B21408
Thermo Fisher Austin TX
09/03/2021

PROPOSAL NUMBER	B21408	PROJECT NAME	THERMO FISHER AUSTIN TX
ORDER NUMBER	B21408 SIZE D	PROJECT LOCATION	AUSTIN, TX
PROJECT MANAGER	TRISTAN PORTER	DWG. NAME	TITLE SHEET
DRAWN BY	TRISTAN PORTER	SCALE: Not to Scale / DWG. DATE: 09/24/2021 / REV. DATE

FREEZER LIGHTING LAYOUT

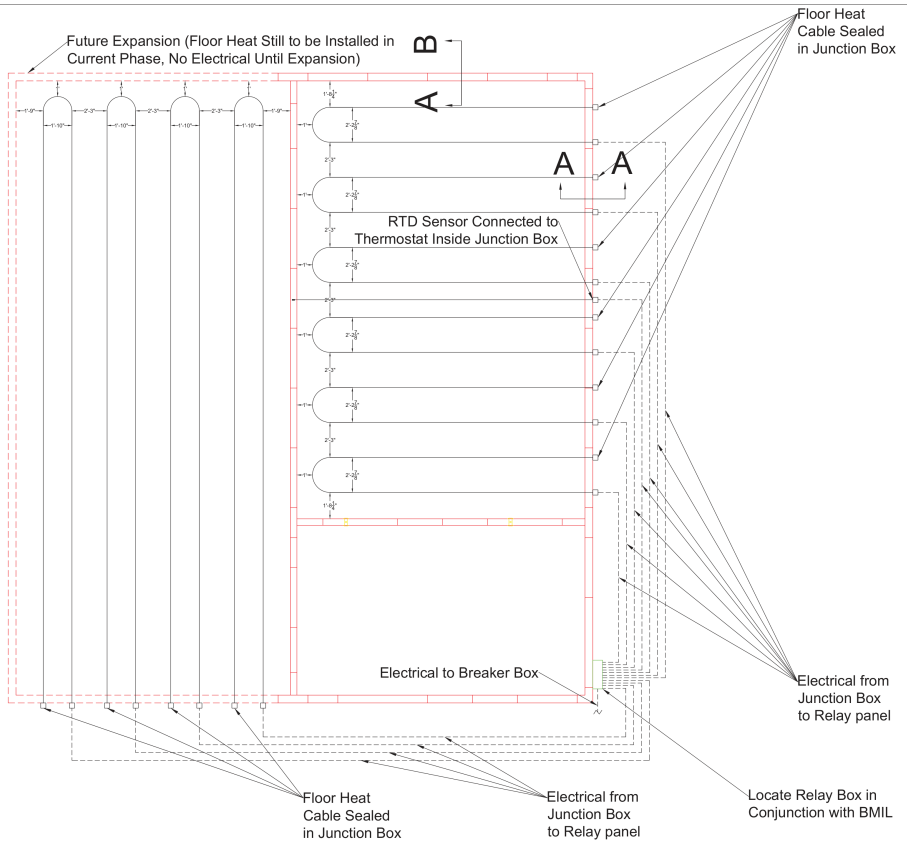
Evaporators moved per sheet G100

We recommend centering this fixture in space it serves.

We recommend adding another fixture to this space.
